Johnson & Sedlack

June 15, 2015

Re: Valiano Specific Plan, SCH NO. 2013061042—Public Comments on Draft Environmental Impact Report

The following comments are submitted on behalf of the Elfin Forest Harmony Grove Town Council regarding the Draft Environmental Impact Report (DEIR) for the Valiano Specific Plan Project.

The Cocos Fire burning above CSU San Marcos, on May 14, 2014

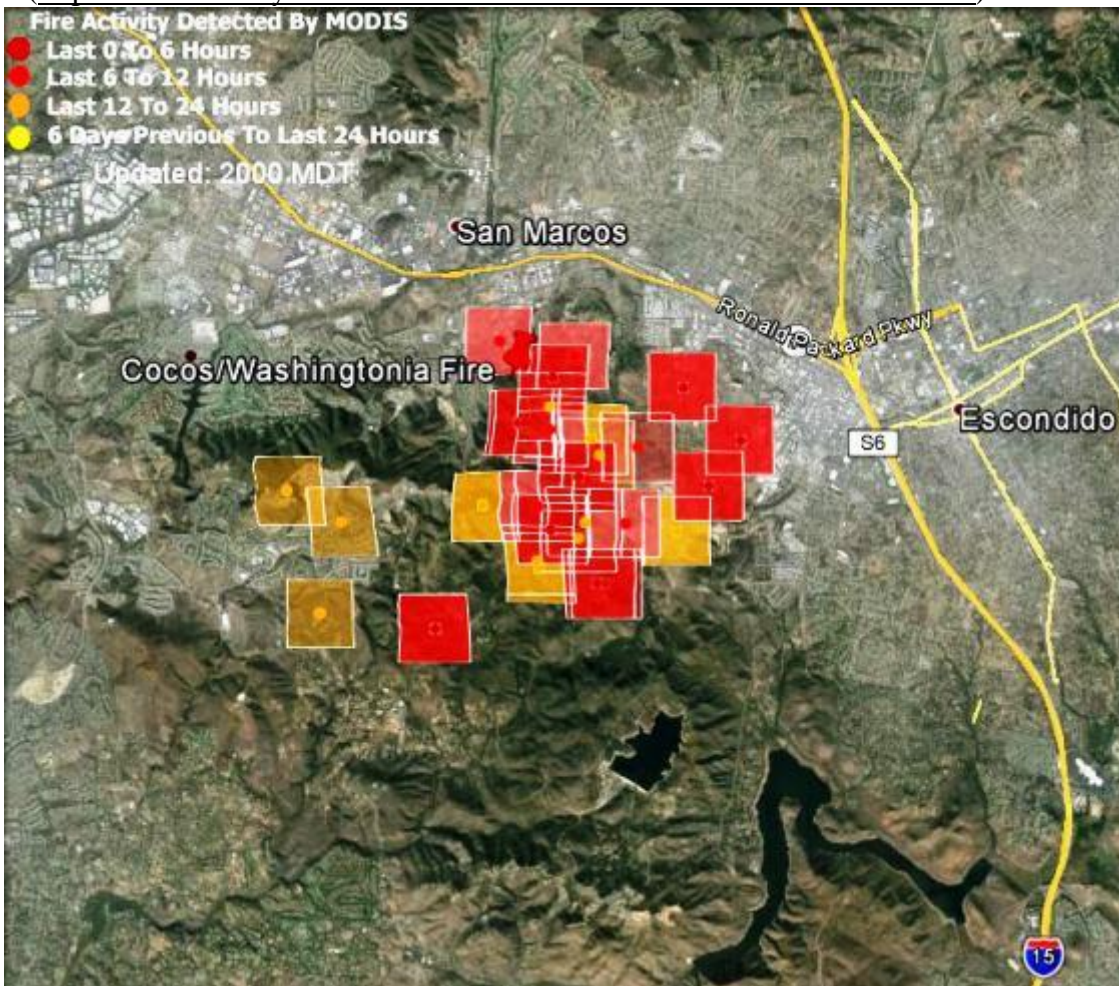
There is only one narrow two-lane road (Country Club Drive) to exit the community⁶, and with only the 80 or so residents of Eden Valley and perhaps another hundred from Harmony Grove, the roads were blocked by horse trailers and traffic, making the exit towards Highway 78 very difficult as traffic was backed up on Auto Parkway and on Country Club Drive trying to turn onto Auto Parkway. To the West, evacuating traffic taking Harmony Grove Road to Elfin Forest Road found itself ensnared in a traffic jam at the corner of Elfin Forest Road and Twin Oaks/San Elijo, with delays of over an hour to try to reach Rancho Santa Fe Road. In the reasoned opinion of residents and area stakeholders, **fire evacuation problems can be expected to increase with the Project.**

The Fire Protection Plan (FPP) (DEIR Appendix L, dated April 2015) does not analyze or the Coco's fire in its historical analysis. This is a major flaw of the analysis and fails to give decision-makers and the public adequate information. Given the seriousness of the impact of that fire on the proposed project location (90% burned) as well as the surrounding immediate area a full analysis of weather and fire-fighting conditions for that specific fire must be included in order for decision makers to fully appreciate the potential impact of adding density in a valley prone to devastating fires.

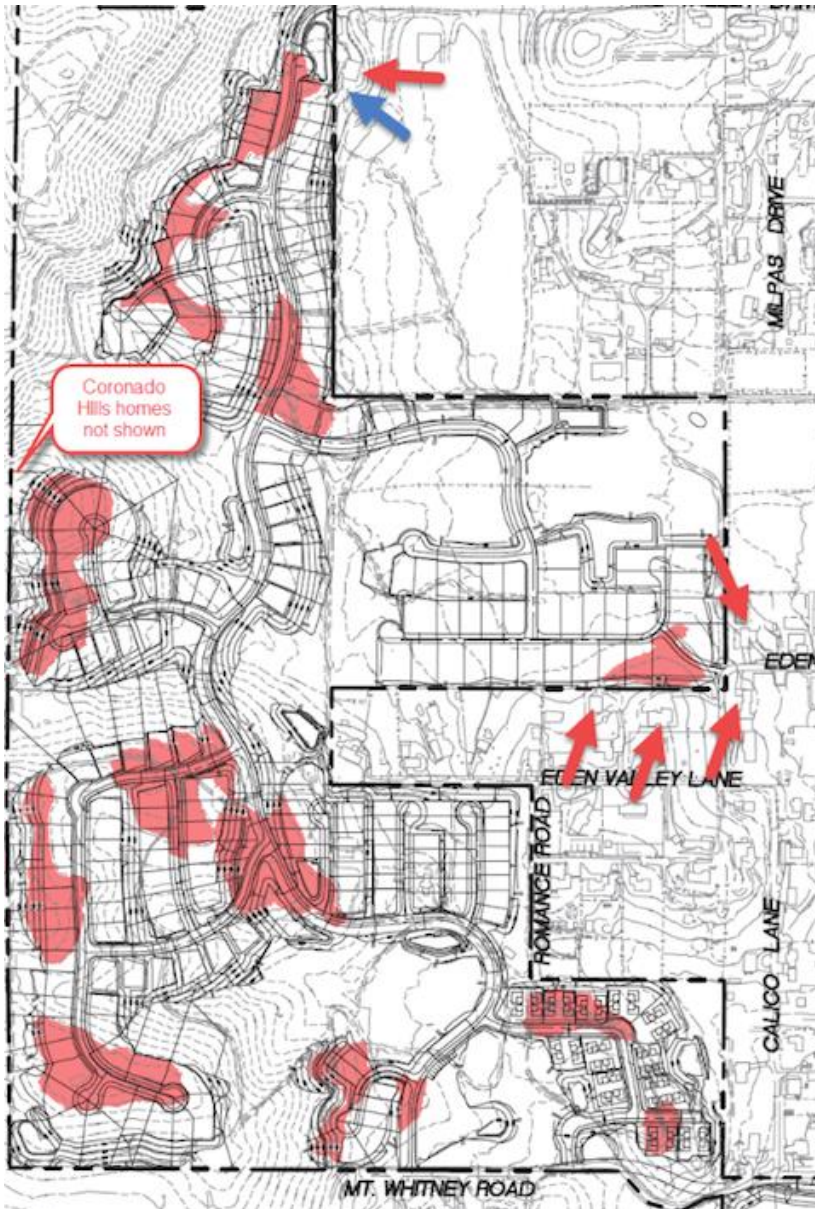
Further, the blasting map below completely contradicts the mitigation measures proposed, since they depict plans to blast well within the 180' of existing homes, which will require drilling. In the image below the red areas are expected blast areas (and, as residents learned from HGV there will be many more than this), the red arrows point to existing homes, and the blue arrow points to an existing well. Note that in Neighborhood 3 blasting is proposed right up to the property lines and the same is true in the northern most section, in complete contradiction with the mitigation measures stated. How can the public and the decision makers fairly evaluate impacts which are obfuscated and hidden in appendices and technical reports when the summary is so very misleading?

The diagram included in the DEIR does not show the homes on Coronado Hills in San Marcos - yet by referencing other maps it appears blasting is proposed right below existing homes, conveniently located in another jurisdiction which does not get to decide on the project approval outcome. *See*, Exhibit A for further reference to Coronado Hills homes.

VALIANO
RPO BUFFERS AND FUEL
MODIFICATION ZONES
SHEET 1 OF 6
AUGUST 8, 2014

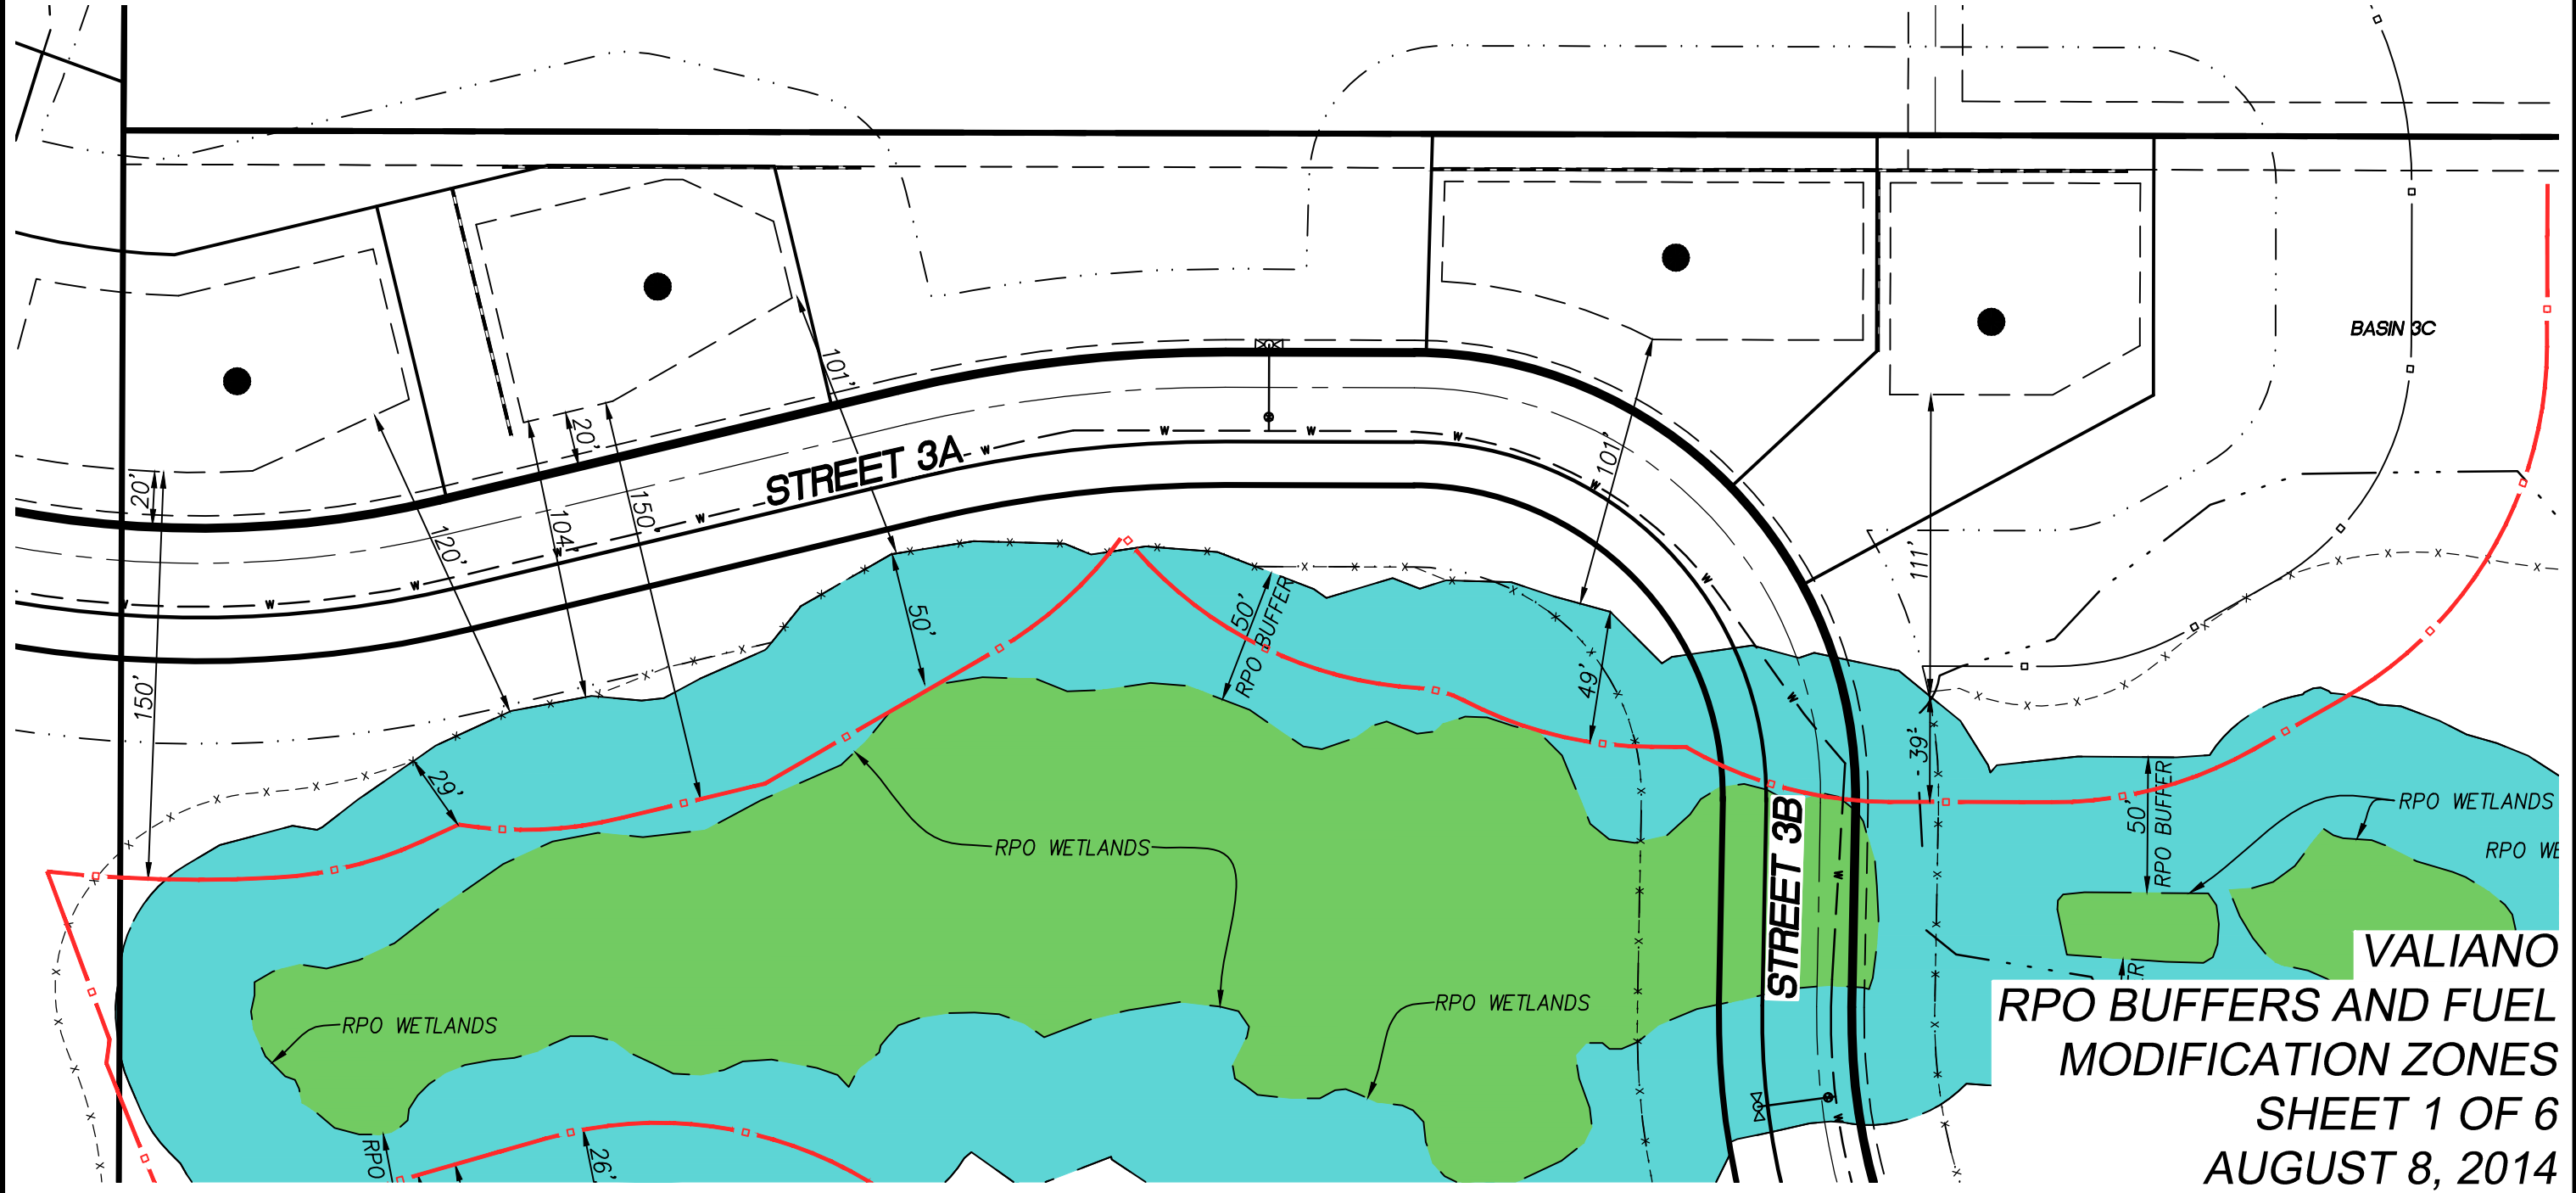
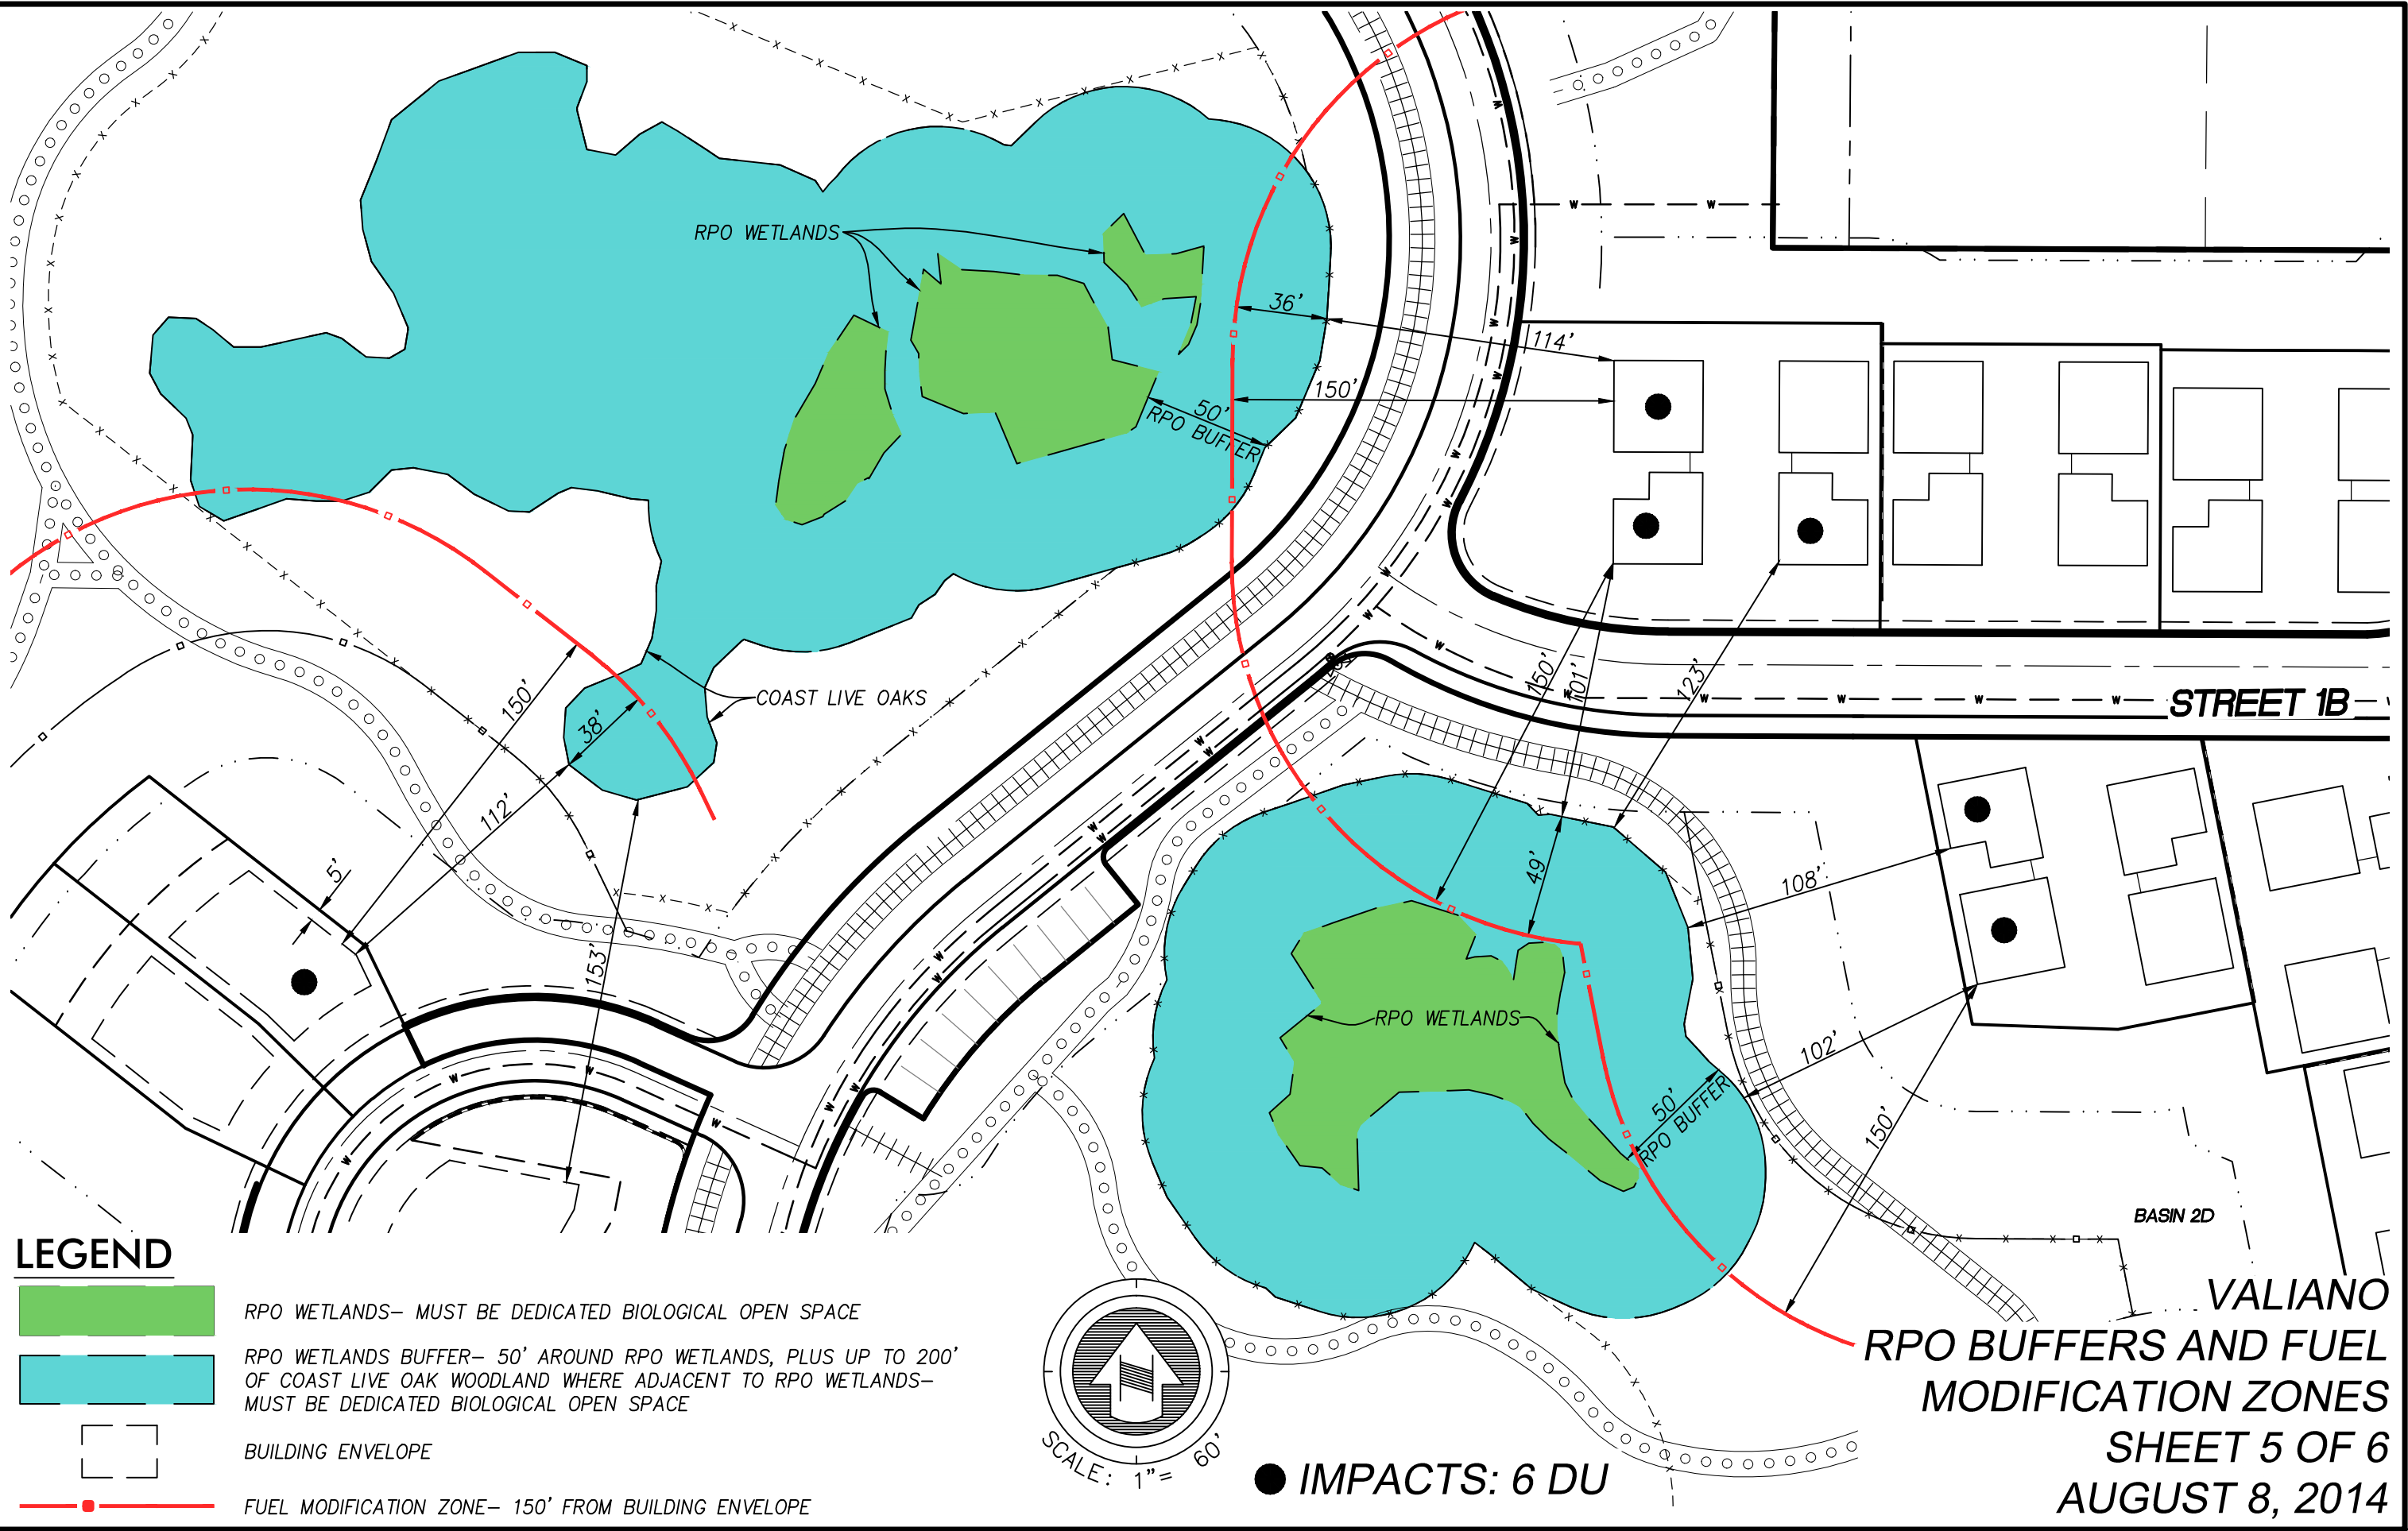
- Do FMZs overlap with areas required for biological mitigation? *See*, attached **Exhibit B** (August 14, 2014 site drawings)
- Section 4.5.3 of Appendix L states regarding Zone 3 (the off-site perimeter parcels which provide the required 150-foot fuel treatment zone for select Project parcels) that adjacent properties will provide the required modification of hazardous fuels 150 feet from off-site structures. There is no assurance that easements can be obtained.
